△ Addendum 1 April 7, 2009

FILE NAME = #FILE#	USER NAME = #USER#	DESIGNED - MAP	REVISD -	STATE OF ILLINOIS DEPARTMENT OF TRANSPORTATION	PAVEMENT MARKING & LANDSCAPING PLAN			F.A.P. RTE. 344	SECTION 146-1S&47WRS-3	COUNTY LAKE	TOTAL SHEETS 176	SHEET NO. 93
	PLOT SCALE = #SCALE#	DRAWN - JRH	REVISD -		SCALE: 1" = 50'	SHEET NO. 5 OF 5 SHEETS	STA. 307+00 TO STA. 334+00	U.S. ROUTE 45 RECONSTRUCTION CONTRACT NO. 60957				
	PLOT DATE = #DATE#	CHECKED - JW	REVISD -									
		DATE - 12-12-08	REVISD -

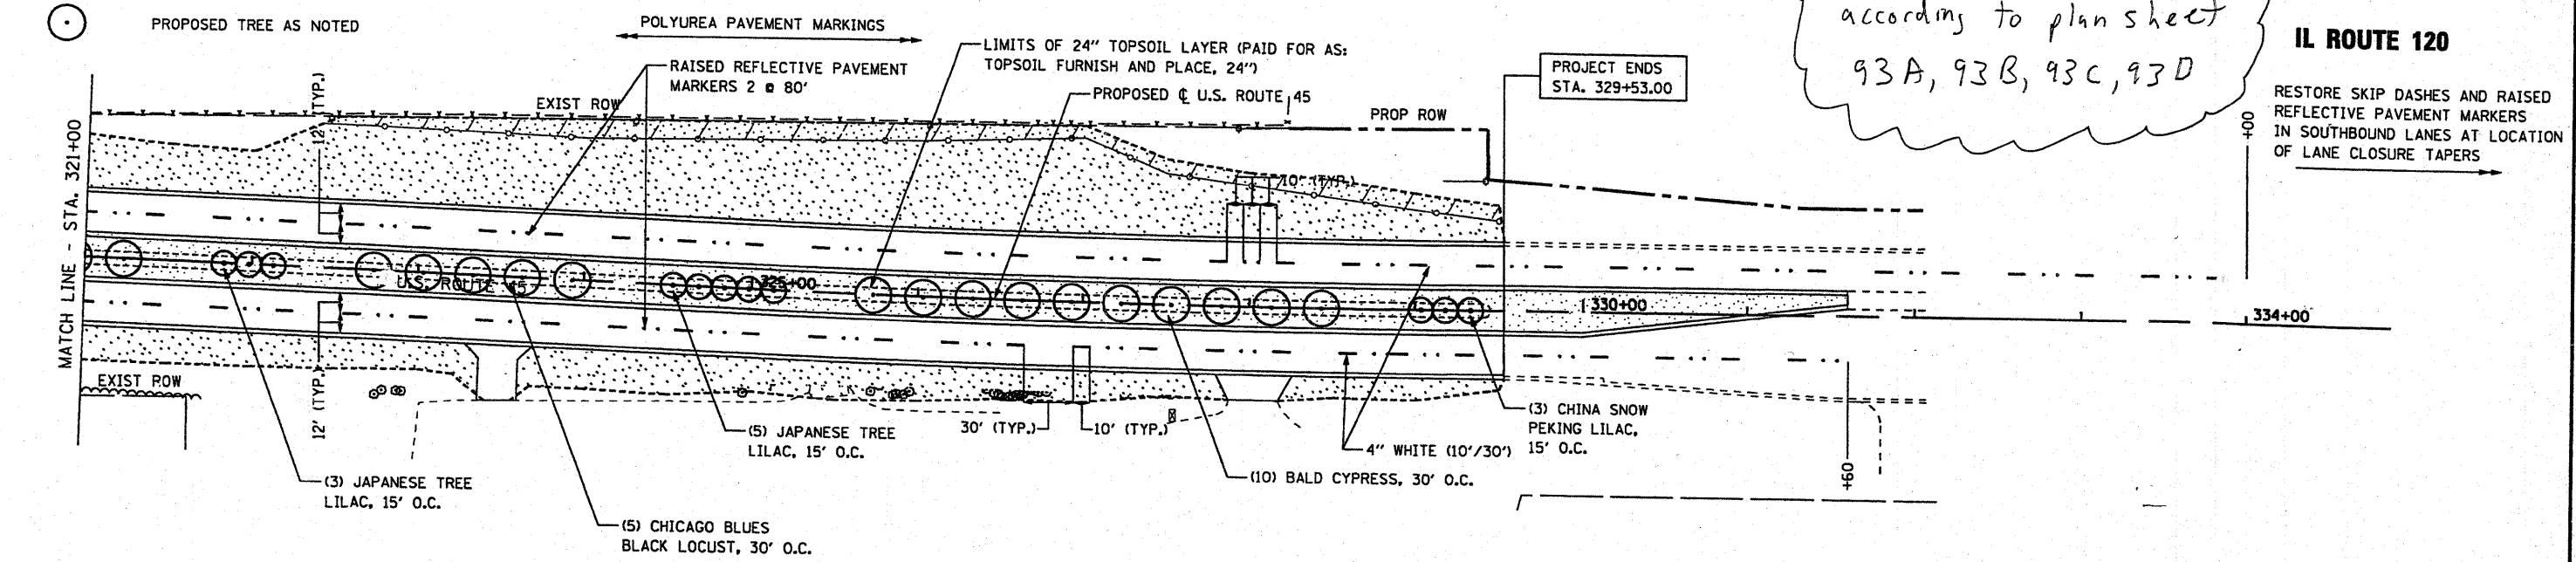
Tree plantings North of Casey Road shall be done according to plan sheet 93A, 93B, 93C, 93D
